Mask Set Errata

MSE908AS60_6J61D
12/2002

Mask Set Errata for 908AS60,
Mask 6J61D

CHxMAX — Channel x Maximum Duty Cycle Bit

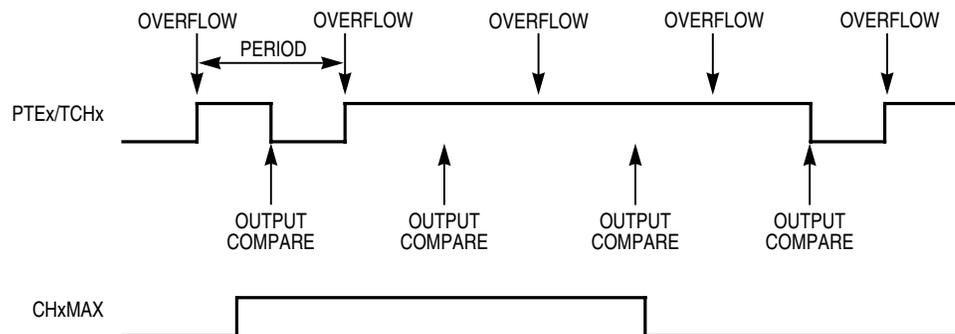
Timer Interface Module (TIM)

SE38-TIM

The PWM 100% duty cycle is defined as output high all of the time. To generate the 100% duty cycle, use the CHxMAX bit in the TSCx register.

When the TOVx is at logic 1 and clear output on compare is selected, setting the CHxMAX bit forces the duty cycle of buffered and unbuffered PWM signals to 100%. As this figure shows, the CHxMAX bit takes effect in the cycle after it is set or cleared. The output stays at 100% duty cycle level until the cycle after CHxMAX is cleared.

NOTE: The PWM 0% duty cycle is defined as output low all of the time. To generate the 0% duty cycle, select clear output on compare and then clear the TOVx bit (CHxMAX=0).
